Murray City Planning Commission Meeting
Notice of Meeting and Agenda

Thursday, September 4th, 2025

ITEM TYPE:	Design Review, Conditional Use Permit, and Preliminary Subdivision		
ADDRESS:	368 West Vine Street	MEETING DATE:	September 4 th , 2025
APPLICANT:	Adam Maher	STAFF:	David Rodgers, Senior Planner
PARCEL ID:	21-12-177-009	PROJECT NUMBER:	25-010 & 011
ZONE:	MCMU, Murray Central Mixed Use		
SIZE:	.20-acre site 5,201 ft ² building 4 units / 682 ft ² of commercial space		
REQUEST:	The applicant is requesting Design Review and Preliminary and Final Subdivision approval to allow the development of a mixed-use project.

Figure 4: Preliminary Plat

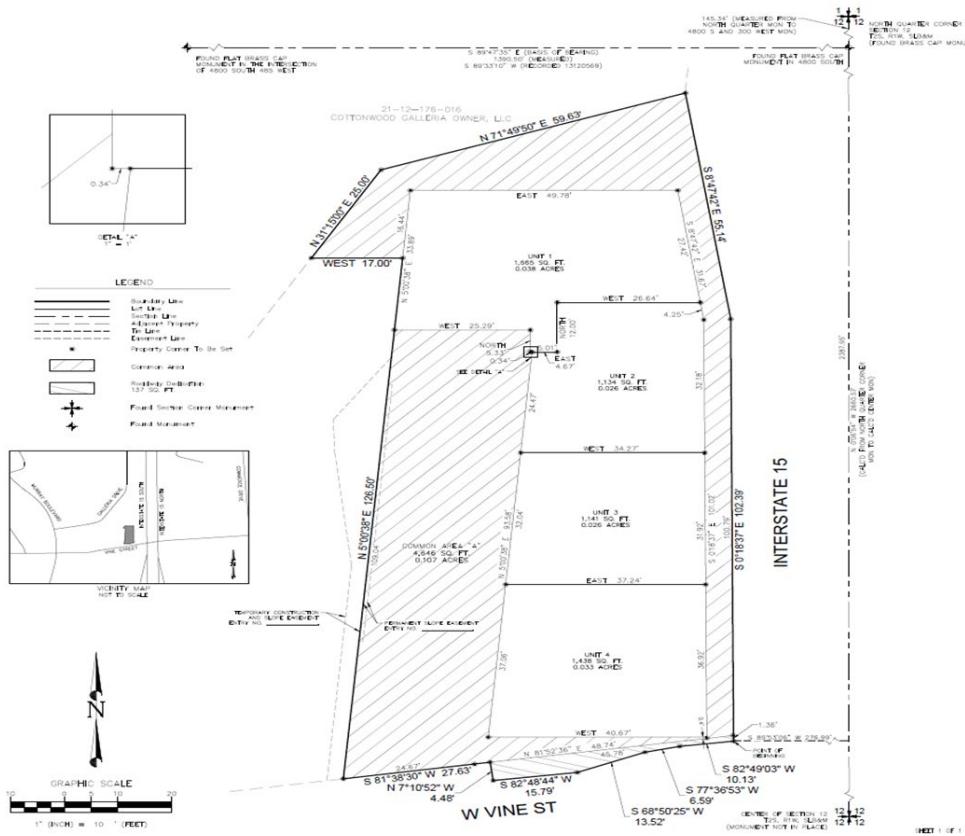
- Obtain construction and slope easements for encroachment on neighboring property.
- Unit 1 extends onto adjacent property. Provide a deed for the proposed property conveyance, the plat will not convey ownership.

- The plat must provide the correct Ownership and Acknowledgements for the signers.
- The plat boundary description does not match the vesting deed, Unit 1 extends onto adjacent property. A copy of the fully executed conveyance deed will need to be provided to the City and the Salt Lake County Recorder's office prior to recording the plat.

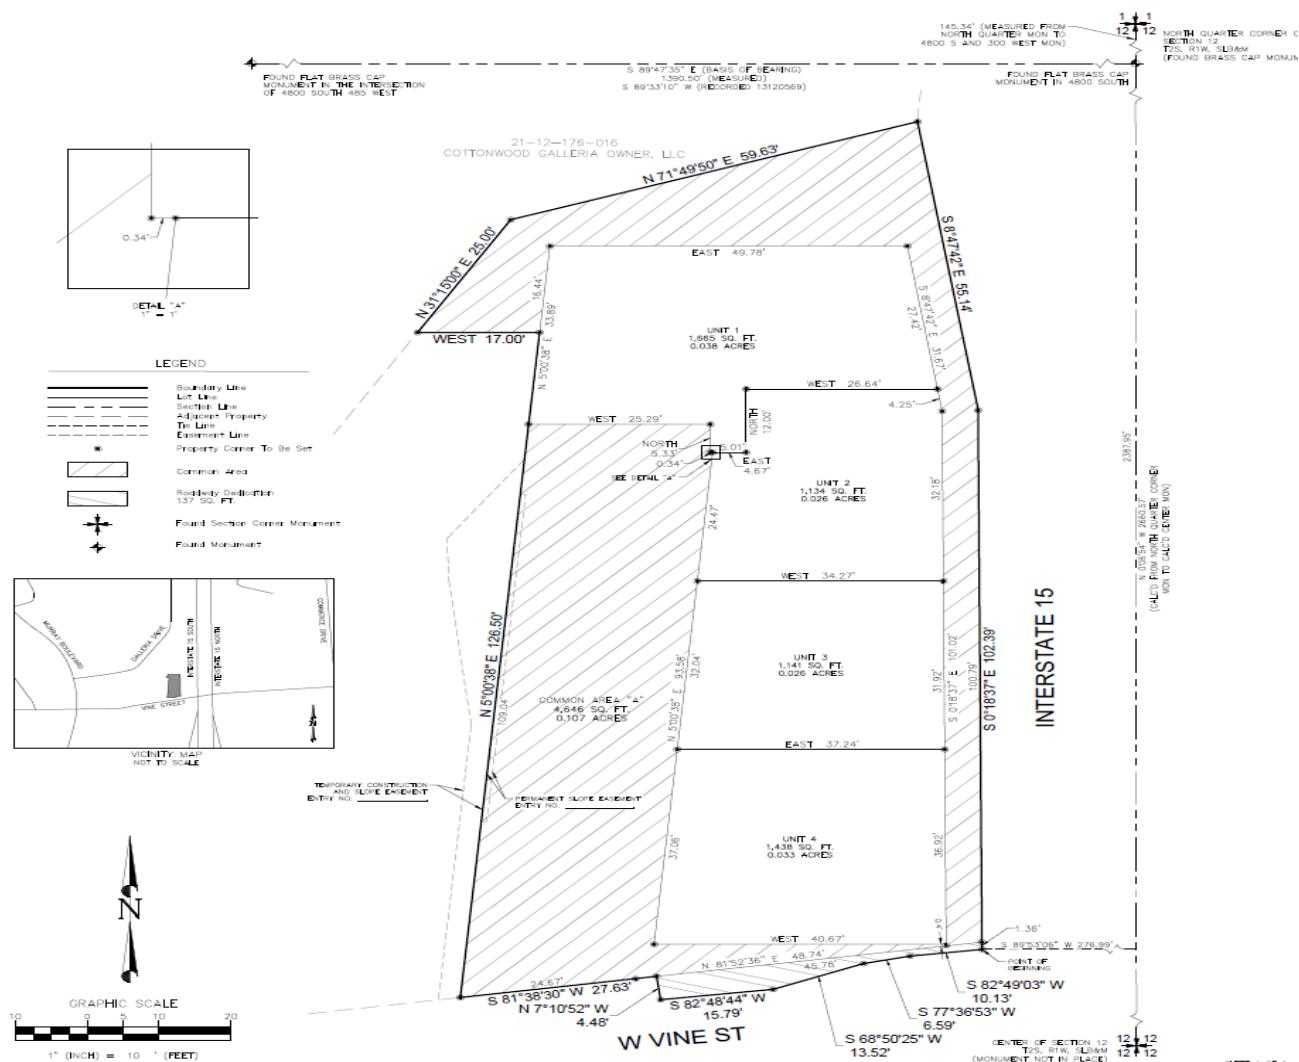
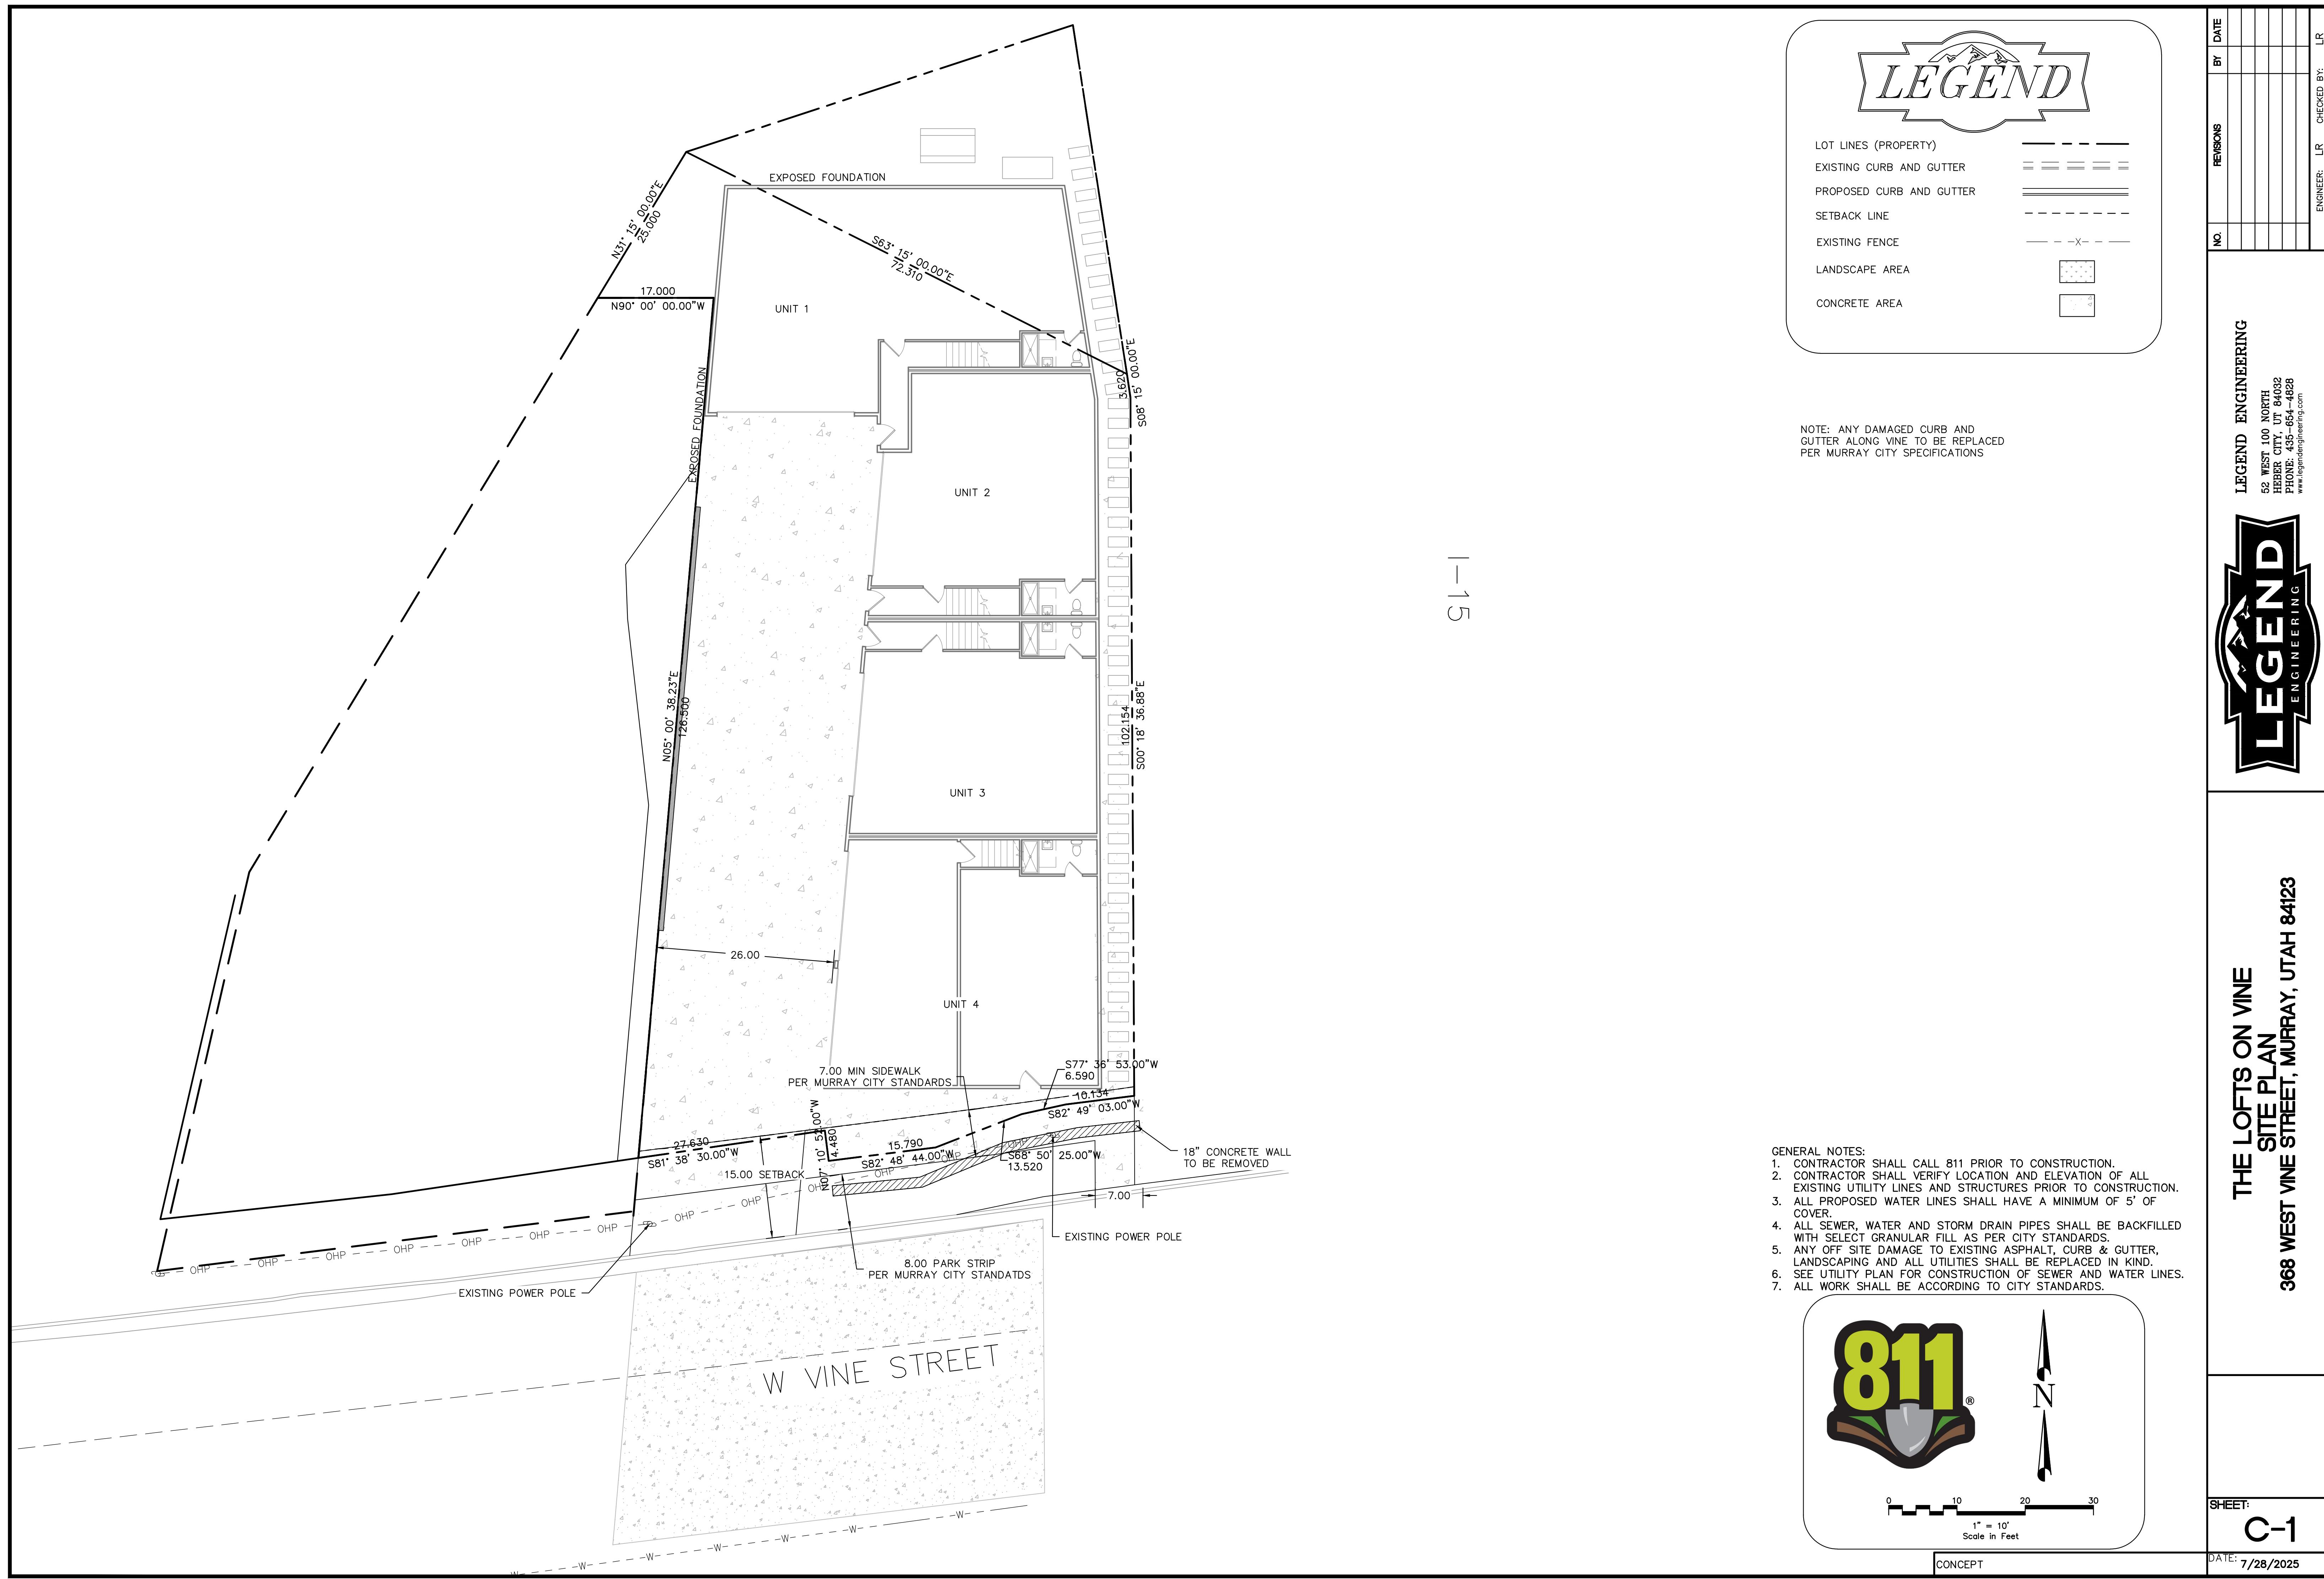
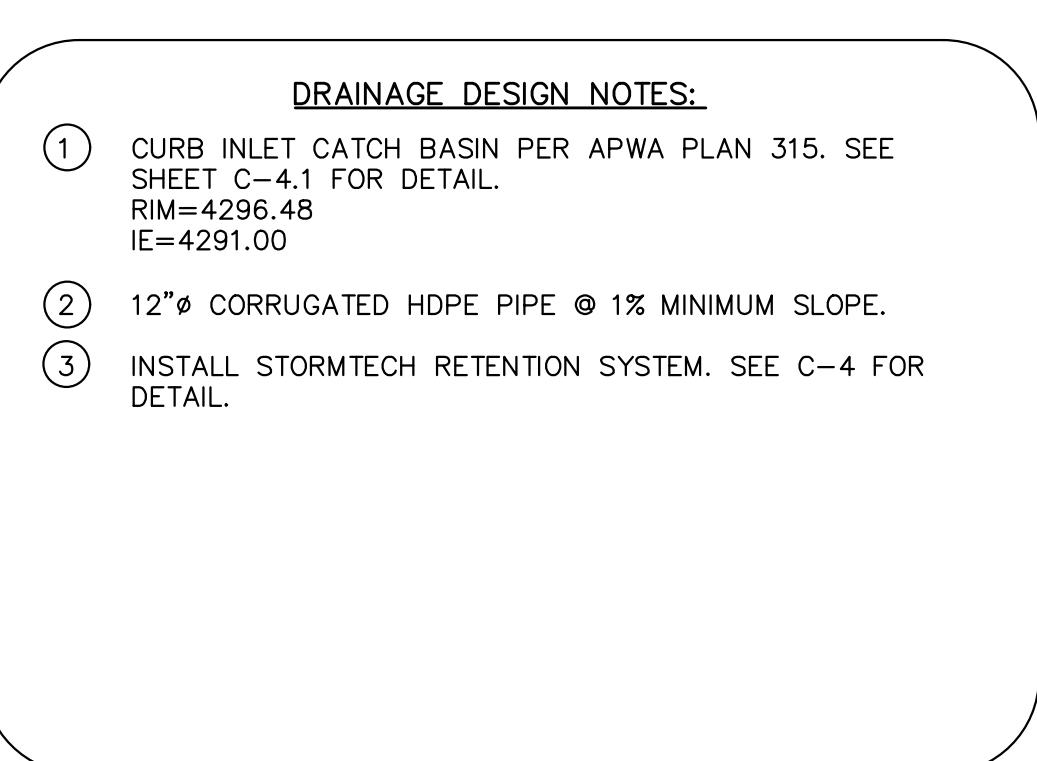
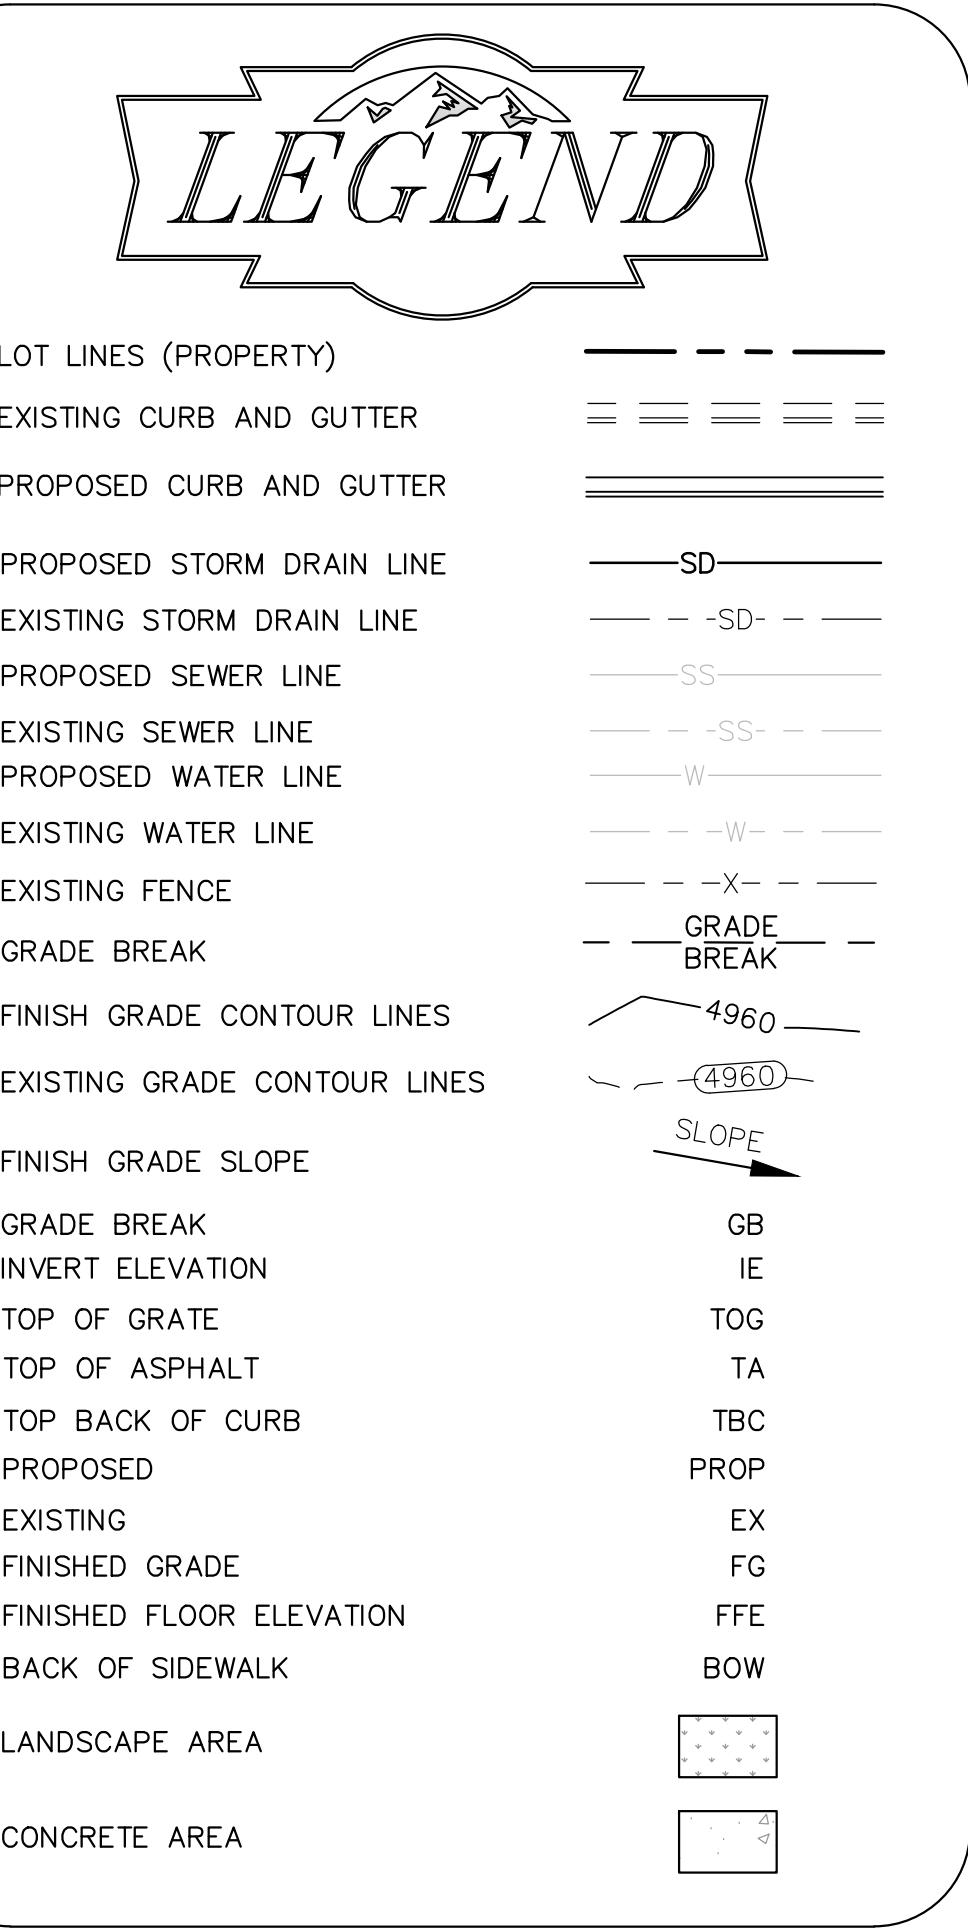
- Civil sheet C-3 comments.
- Clean outs must be placed where lateral leaves the building, not at the sewer main. Correct placement and comment 2.
- Clean out size must match size of the lateral, 4" lateral must include 4" clean out.
- Dead end manhole in property can be 4 FT manhole not 6 FT as listed in comment #5
- New manhole in Vine Street must be a 5 FT manhole not 6 FT as listed in comment #4.
- Sewer lateral for far North unit should tie into the dead-end manhole. This will provide for better cleaning access in the future and eliminate one of the clean outs on this lateral.
- Please provide what the separation distance will be between the storm tech system and the proposed sewer main. Please provide a profile view sheet showing the sewer main elevation and the storm tech elevation.

Meter Box Installation

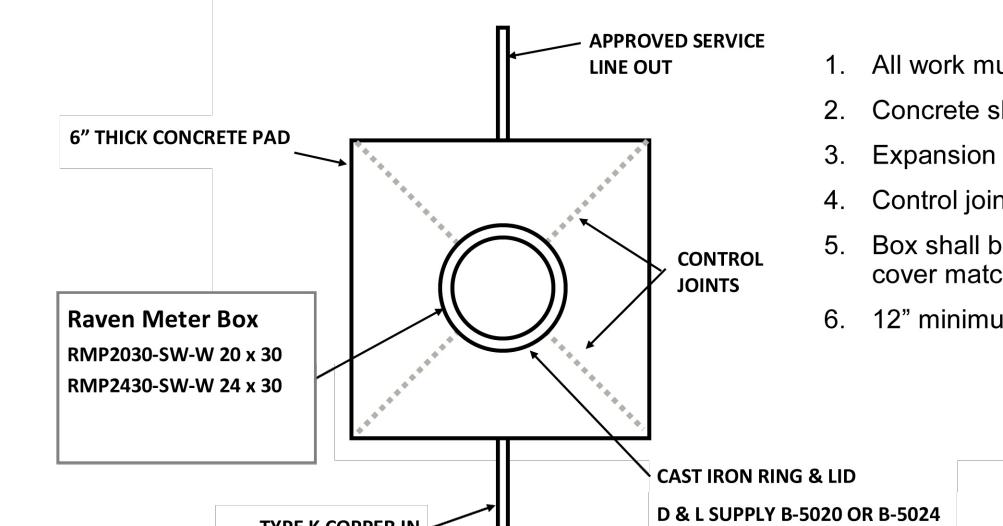
- All water utility work must follow Murray City Water Specification and Requirements.
<https://www.murray.utah.gov/DocumentCenter/View/16910/Murray-City-Water-Specifications--Requirements-2024>
- Change Meter Box Installation Detail (Page 16), with the current detail (Page 17) within the water specifications & requirements. The city now requires a polymer lid. If the lid is within landscaping, it is a 12.25" OD Polymer Solid Meter Lid. Must be black, large pentagon bolt, polymer worm gear, Water stamped on lid. To fit the appropriate ring.
